Libas Textiles Ltd (9500)

22.MARCH.2014

Identified Priority 1 Concerns

Building 2 Column rundown with scanned rebar is insufficient (RED)

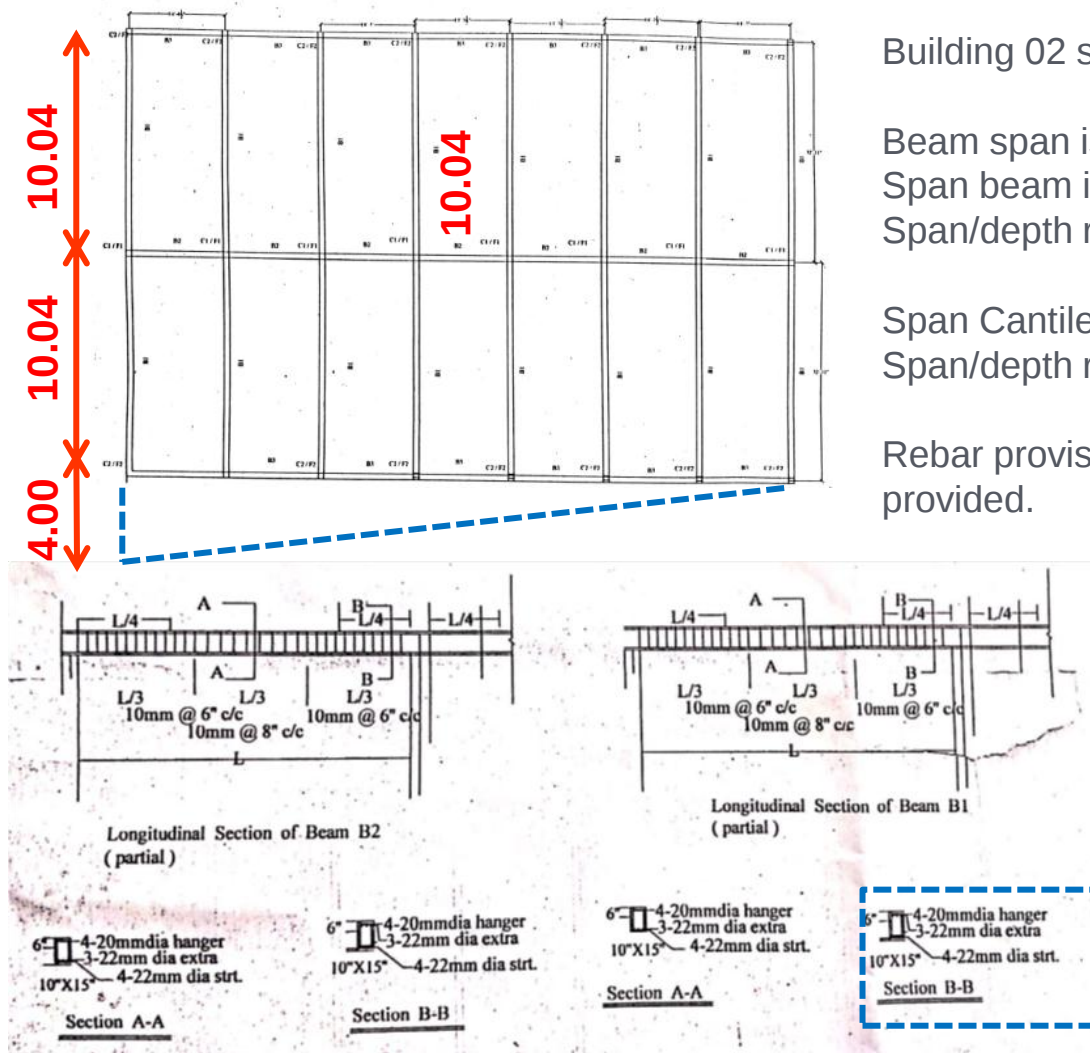
Based on the load rundown analysis following the agreed minimum design live load assignment, the columns seem significantly insufficient in carrying the dead and live loads from the 3 storey in building 02, giving a firm RED warning. The building was constructed before 2005, with brick aggregate, with total of 3 storeys (including roof). In addition, the ferroskan indicated a steel provision which was not in accordance with the record drawings

Building 02 is deemed unsafe for usage due to unsafe structure on all aspects.

- Cease operations in Building 02 immediately
- It is deemed that the building is unusable based on the current structural layout

Building 2 Beam is propped at midspan by temporary steel post on ground-bearing slab

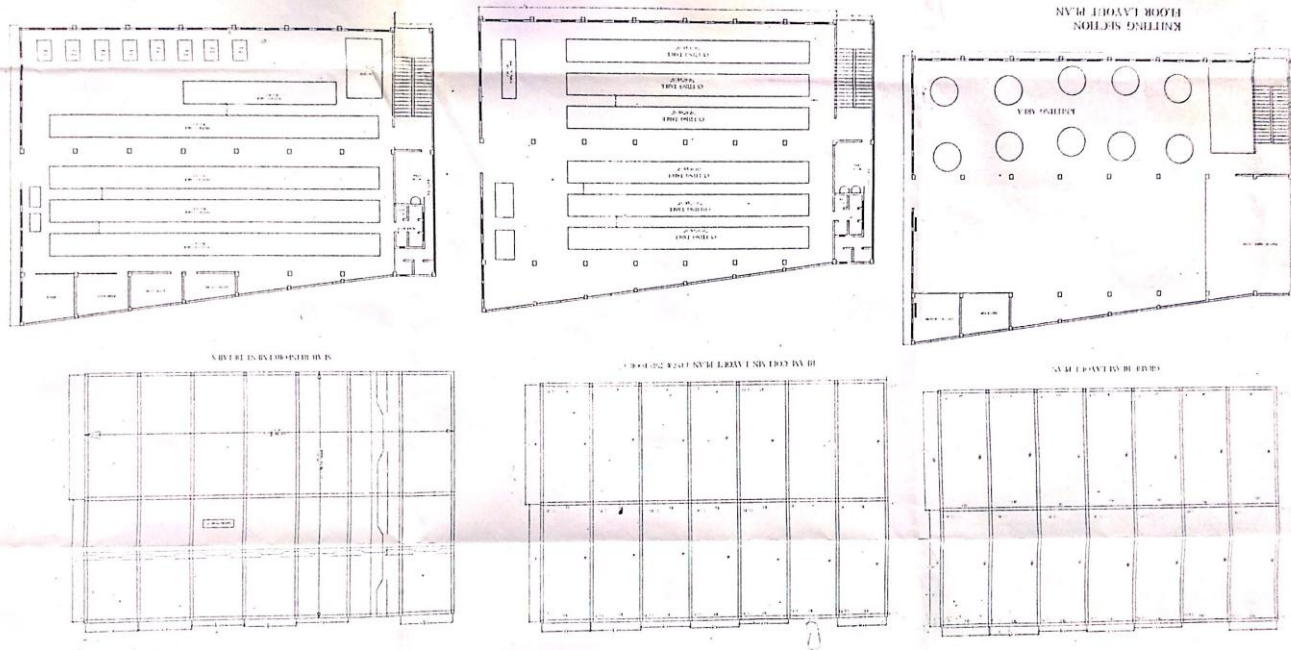
Temporary steel post

Top and Bottom connection

A previous inspection by a structural engineer also proved that the structural integrity of this building is of major concern. Steel props have been added to the mid-span of the beam as a temporary measure to provide stability, however their installation was not considered to be safe, as none of the surface finishes of the beam were removed, and the punching shear on the floor slab is also of major concern, as there is no foundation directly beneath these posts.

Fire escape staircases are not suitable for emergency use

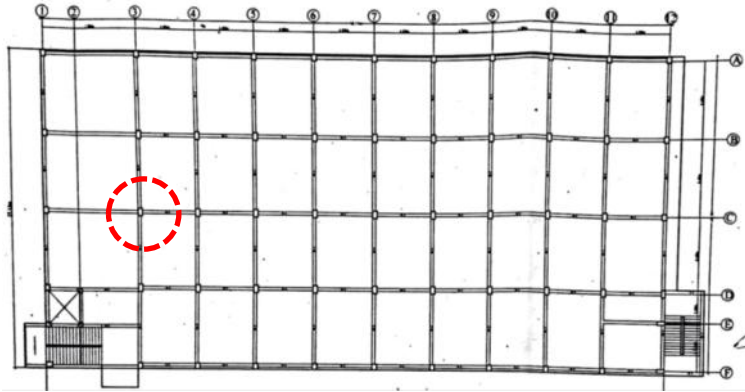
The fire escape staircases were added by the factory owner after completion of the building.

These staircases are deemed to be unfit for their purpose as the structural framing does not appear to be able to withstand emergency crowd loading. The balustrades are also not designed to take lateral crowd loading, and all the members have not been galvanised. Significant rusting of all the steel members was observed

- Consider to replace the staircase and design in accordance with emergency escape regulations with regard to loading
- Apply galvanised coating to all steel members if a new steel structure is chosen.
